# UNITED STATES PATENT AND TRADEMARK OFFICE

APPLICATION NO.	FILING DATE	FIRST NAMED INVENTOR	ATTORNEY DOCKET NO.	CONFIRMATION NO.
09/801,695	03/09/2001	Toshiro Hayakawa	Q61191	3297

**Office Action Summary**

**FIG. 1**

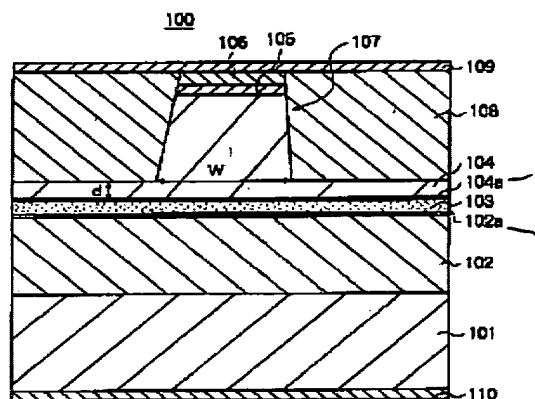
Claim 8 is rejected under 35 U.S.C. 102(e) as being anticipated by Hirata (PN 6,195,375).

Figure 1 illustrates a semiconductor laser having lower and upper cladding layers (102), (104), an active layer (103), lower and upper guide layers (102a) and (104a)

where the upper guide layer has a thickness smaller than the lower guide layer and a stripe width ( $W$ ) of  $0.4\text{ }\mu\text{m}$  or less, as described in the abstract and columns 6 and 7.
